4100601 Precast Concrete Box Culvert.
COMMENTS FROM INTERNAL/INDUSTRY REVIEW

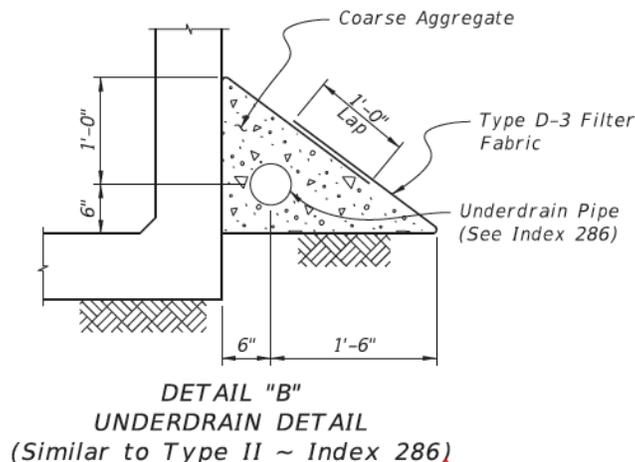
Comments: (11-12-11) Text: The problem statement on the Origination form states: Weep holes in box culverts are not always required by design; however the FDOT Specifications currently requires weep hole in all box culverts. This should probably be corrected since current specifications only require weep holes in culverts with a wall height in excess of 5'. The origination form does not indicate whether or not there is a corresponding change to the Plans Preparation Manual associated with this change. Since the proposed specification change will now require weep holes for culverts to be shown in the Plans, it is suggested to confirm that this requirement is also included in the PPM. It is suggested that the proposed last sentence of paragraph 1 of 410-6.1 not be implemented since the proposed changes to 400-6 will already require construction of the weep holes only when shown in the plans. Further, the plans (or a Standard Index) should provide all additional prescriptive elements (details) which are outlined in the current & proposed specifications, including but not limited to: • Symmetrically located weep holes. • Weep holes that are 3" in diameter & not more than 10' apart. • Weep holes that are not placed under areas of base or pavement. • Outlet ends of weep holes placed just above the ground line in front of abutments & retaining walls. • Weep holes on culverts that are placed approximately 6" above the interior floor slab. • Exterior openings of weep holes covered with galvanized mesh with a minimum of 2cf of clean, broken stone or gravel wrapped in Type D 3 filter fabric. Thus, the changes to 410-6.1 and the additional information proposed as 410-10.6 should not be needed.

12-2-11 From the State Specifications Office (HRP): Based on conversations with Andre, the proposed language describing weep holes in box culverts will not be implemented. There is no apparent need to provide weep holes in box culverts and the current requirements in Article 400-6 cause confusion in the field resulting in questions. If for some reason, a designer feels weep holes are needed then the details would be shown in the plans. A continuous underdrain will be required for box culverts to aid in drainage as shown above.

The Problem Statement in the Origination Form is changed as follows:

Weep holes in box culverts are not always required by design; however the FDOT Specifications currently requires weep hole in all box culverts over 5 feet in height.

The comments regarding changes to the PPM and Design Standards were forwarded to the State Drainage Office for possible inclusion in the 2013 PPM and Design Standards. The new detail that will be shown on sheet 5 of Index 289 of the 2012 Design Standards is shown below.
